Re: Concerns regarding the Council File (CF 14-0656) -Proposed Revisions to the BMO/BHO dated
01.13.17

re: File # 14-0656, CPC-2015-3484-CA

re: Council File #14-0656**Baseline Mansionization Ordinance / Stabilize the Conflict of Out-of-Scale Homes**

① Section 1
1/8" = 1'-0"

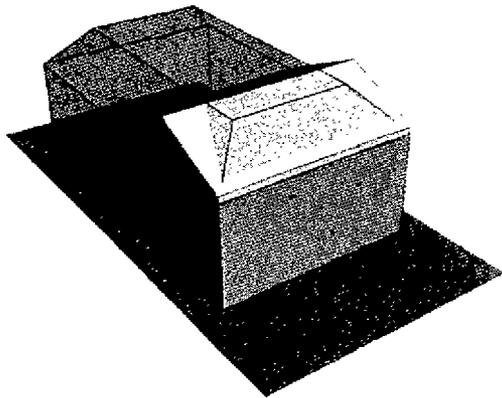
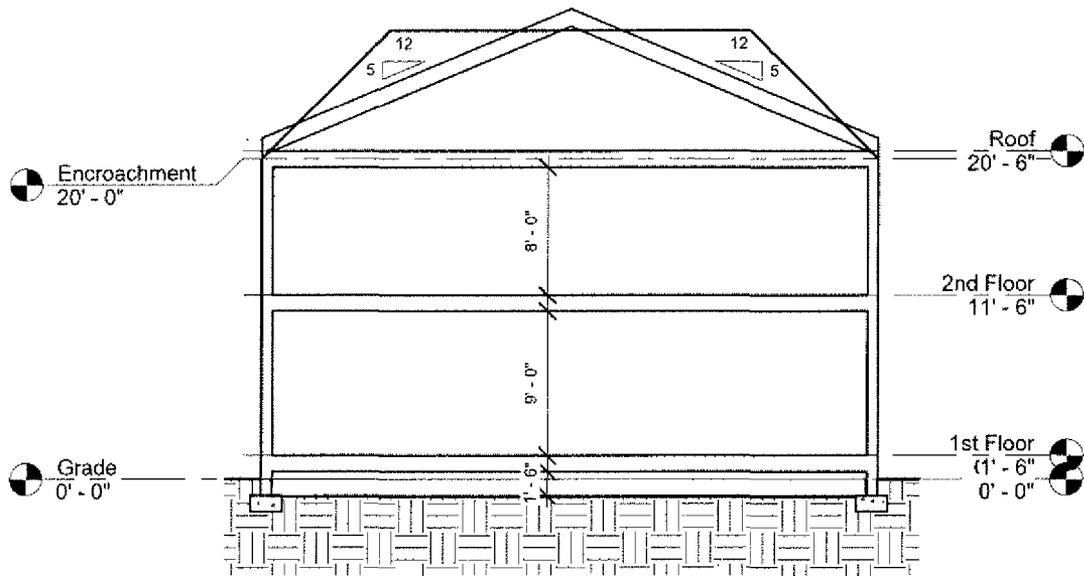
20' encroachment plane height is insufficient to allow a typical construction 2-story addition on an existing home with raised floor foundation (most all of LA's existing R1 fabric) and side walls on the setback line (see diagram 2 section). Existing homes would incur significant costs for a new foundation line. By discouraging their renovation, *the 20' limit encourages the demolition of existing homes* for new structures with slab on

Simple home with
raised floor per code,
5:12 sloped roof

grade. 22' is a more reasonable encroachment plane height to allow full-height second-story additions to existing structures.

① Section 2
1/8" = 1'-0"

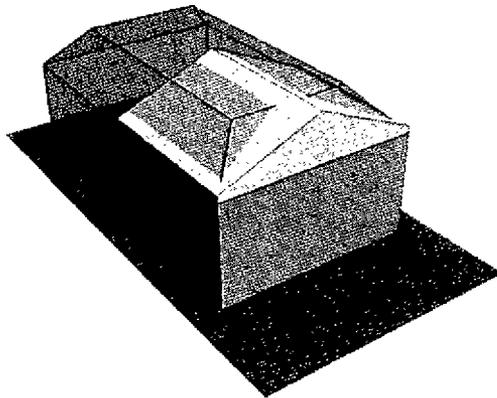
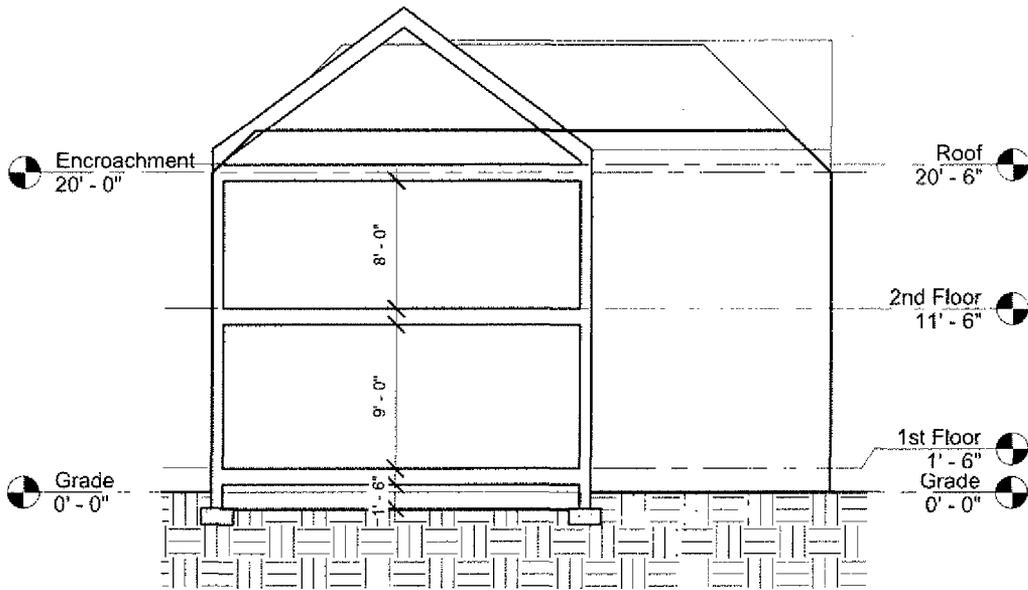
No allowance for even limited protrusion through the sloped planes of the encroachment plane is *extremely detrimental to stylistic variety and excellence in design*. Attached diagrams 1 – 4 illustrate but a few examples using a 50' wide lot.

A two-story Colonial style home design (with a ridge parallel to the street) would not be possible on a 50' wide lot without such accommodation unless the home width is reduced by 16' to a mere 24' wide with 13' side yards. The designs of Craftsman, Victorian or Cape Cod style homes where side gables and dormers are predominant would be severely hampered to the point of encouraging bad design. And when attempting to lower the roof top plate to avoid the maximum height, useable spaces are not possible without dormers the encroachment plane precludes. Even the design of flat-roofed contemporary homes (which the "preservation" bent of this change seem to be directed to discourage) would be negatively affected on the typical 50' and narrower lots forcing completely and consistently symmetrical "wedding cake" designs for a reasonable width second story.

Simple home with
raised floor per code,
5:12 sloped roof

Allowance for limited protrusions through the sloped planes would allow for greater variety in design, asymmetries and details on which design excellence of most home design depends. Such accommodation would also not significantly impact the light and space intent of the sloped planes, especially with more traditional designs. Pacific Palisades Tract 9300 has developed language to accommodate limited encroachment plane protrusions and I recommend similar allowances be incorporated into this revision.

1 Section 3
1/8" = 1'-0"

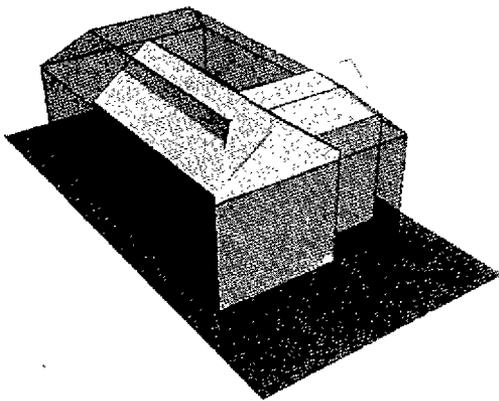
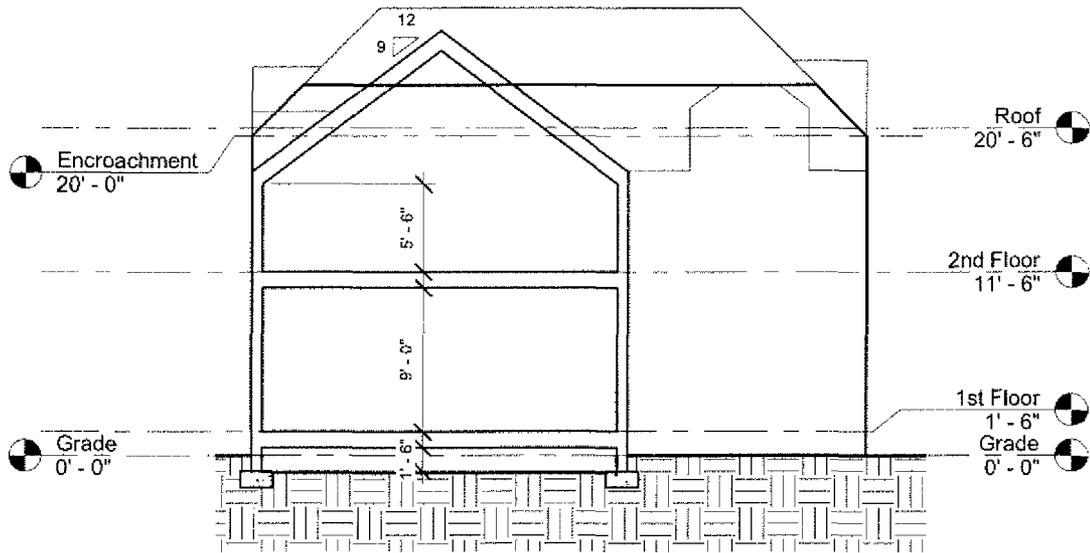
More articulated home
with raised floor per
code, 9:12 sloped roof

① Section 4
1/8" = 1'-0"

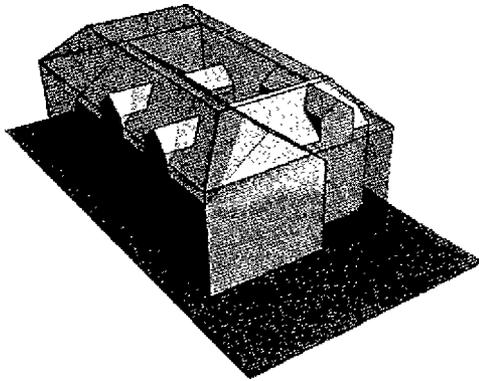
More articulated home with raised floor per code, 9:12 sloped roof lowered to avoid height restriction, dormers added for second story usability.

Hillside Encroachment Plane diagrams (not to scale)

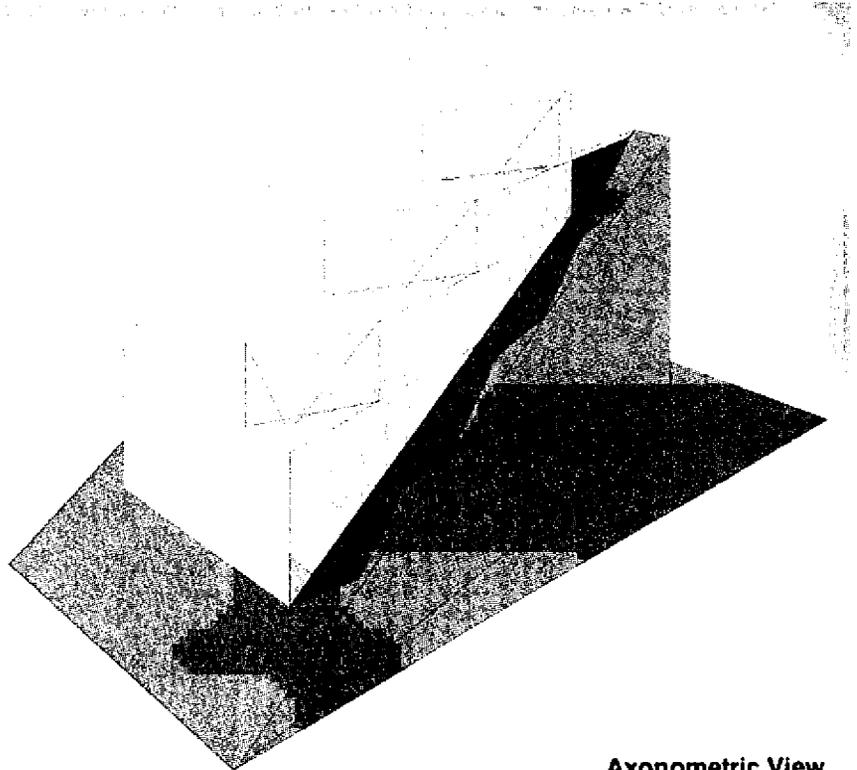
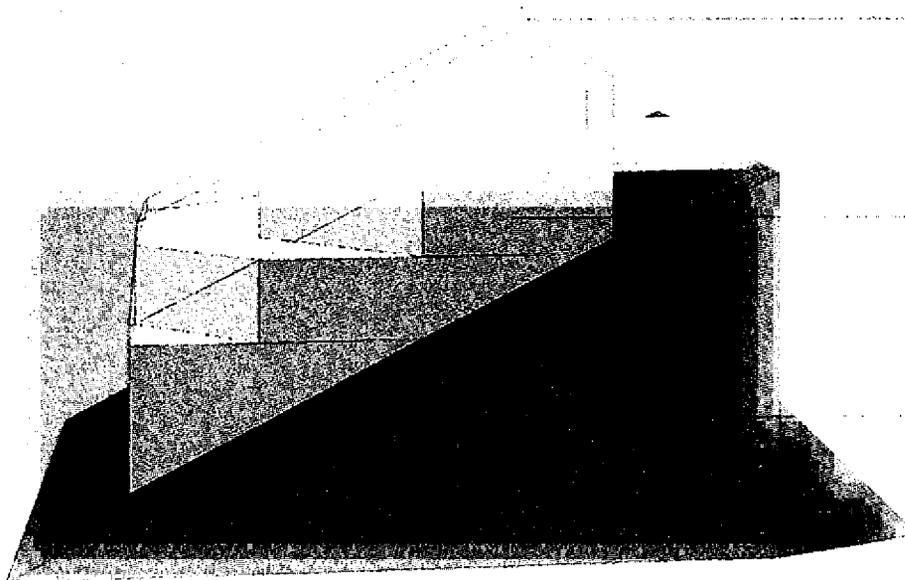
- 1. Please omit the 45 degree encroachment plane for Hillside areas** - While this provision may be appropriate for relatively flat properties, *its impacts have not at all been considered* on a Hillside lot where a structure is already constrained by a sloping height envelope (parallel offset to the topography) as well as lot coverage. The intersection of the encroachment planes to a sloping height envelope will create *virtually unusable, wedge-shaped floor plates* and force such a complicated, unconventional design that will render future projects infeasible. Our office has modeled this provision on a conventional 50 foot x 100 foot parcel with a 2:1 downslope. Please review the attached diagrams provided to illustrate what I am confident are dramatic and unanticipated effects of this provision.

Intersection of Floor volumes with encroachment plane produces irregular, wedge shaped floor plates. (10 foot floor levels assumed)

- 5. Either eliminate the 45 degree encroachment plane** - or the additional side yard setbacks - It is redundant and confusing to require additional side yard requirements (beyond the minimum) based on height of structure *and also* require an encroachment plane. These serve the same purposes. Please eliminate the encroachment plane in Hillside areas.
